From: s 9(2)(a)
 Sent: Wednesday, 11 March 2020 4:30 PM
 To: Barry Wright <Barry.Wright@nzta.govt.nz>
 Subject: RE: Welded rebar in bridge decks - confidential

I have been investigating deck solutions for the Okahu and Puhoi Viaducts.

PŪHOI TO WARKWORTH MOTORWAY

| Title | PRECAST DECK PLANKS REINFORCEMENT DETAILS - SHEET 3 | Drawing No. | P2Wk-DRG-SE-19-0107 |

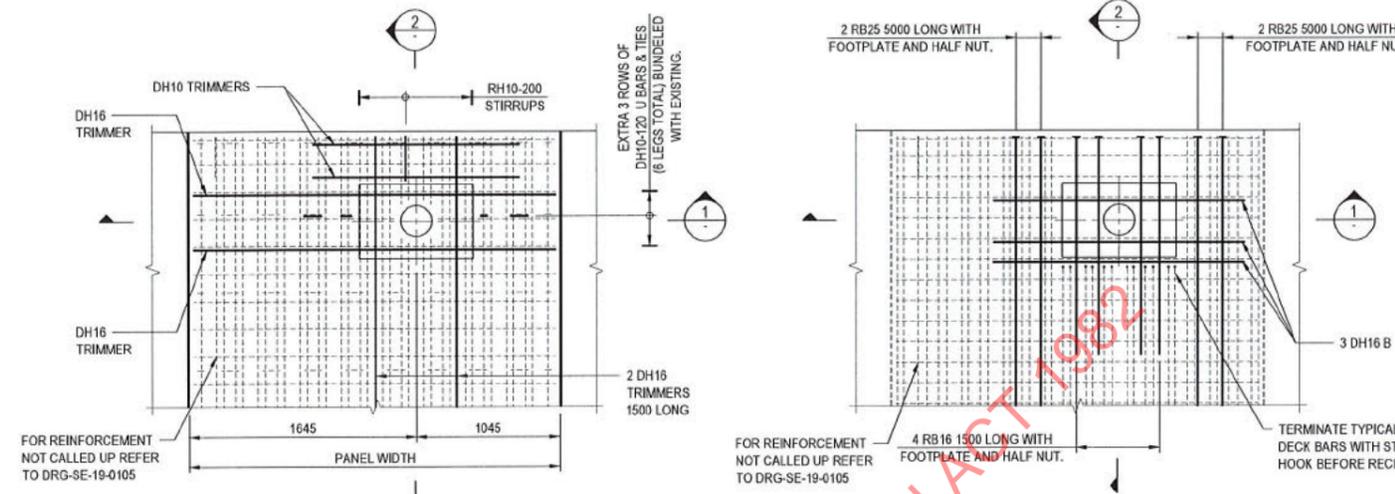
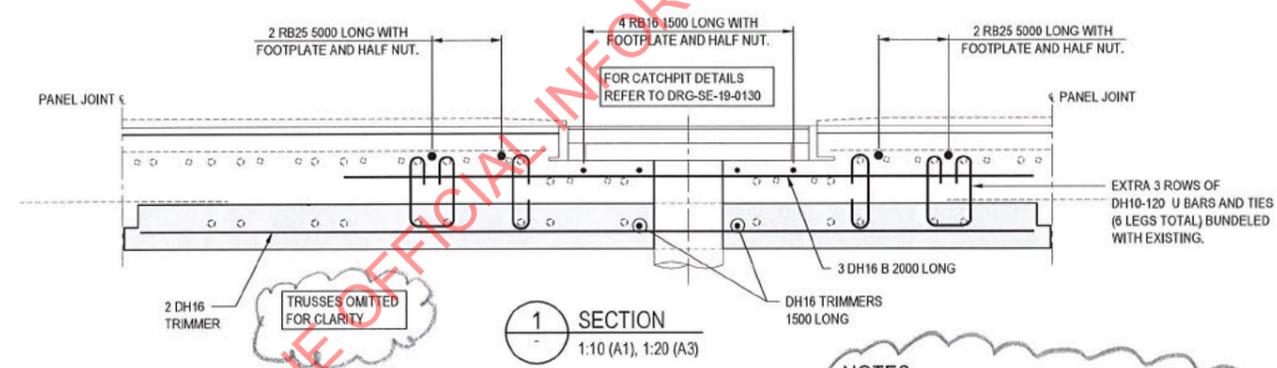
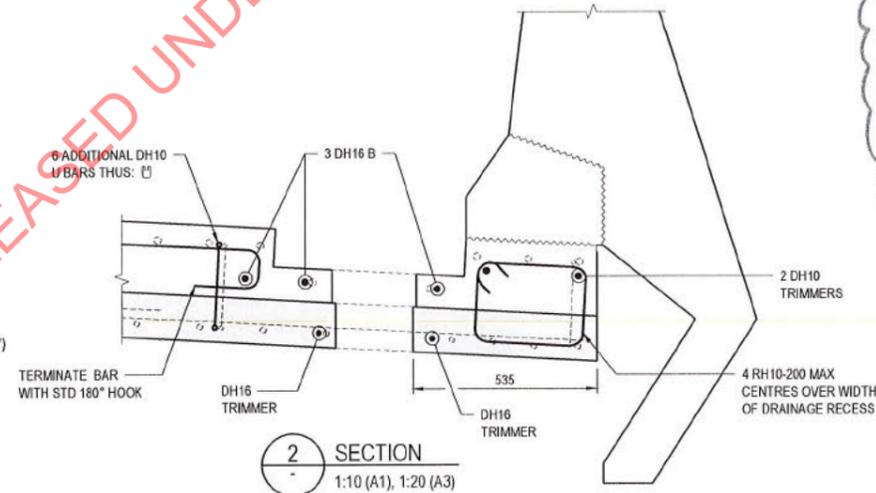
The following pertinent points can be made from drawing P2Wk – DRG -SE-18-0107 Rev A dated Aug 2017.

1. The designers intent was that temporary reinforcing truss (i.e. That is the heavily welded 500 grade rebar trusses from Spain?) were only required for strength during construction, but would remain within the permanent deck slab.
2. The designer intends the temporary reinforcing truss to be considered redundant for the permanent works due to fatigue issues caused from welding of the truss bars. E.g. my concern.
3. The designer intent was the temporary truss system design to be finalised by the Temporary Works Engineer and checked with the Design Engineer.

4. Given what is on the drawings has got to construction I would assume the Peer Reviewer has scrutinised and approved this.
5. The likely failure mechanism of this deck system should be checked by fatigue trials or previous examples.

6. My hypothesis of the probable failure mechanism is as follows:
 - a. The deck slab spanning transversely across the 4 girders and cantilevering outwards is very stiff with both the required deck reinforcement and the additional stiff temporary reinforcing truss. The truss chords are at the same depth as the deck slab transverse bars. I assume no reliance has been placed on the temporary reinforcing truss in the design of the ordinary slab reinforcement.

- b. After a period of service loading the temporary reinforcing truss begins to crack due to fatigue loading at quite low cyclic stresses. The truss is likely to snap in regions of highest strain. That is over the girders (hogging moment) and between the girders (sagging moment) but breaks could be at any weld or stress riser along the length of the trusses. The location of fatigue cracking is practicably unpredictable.
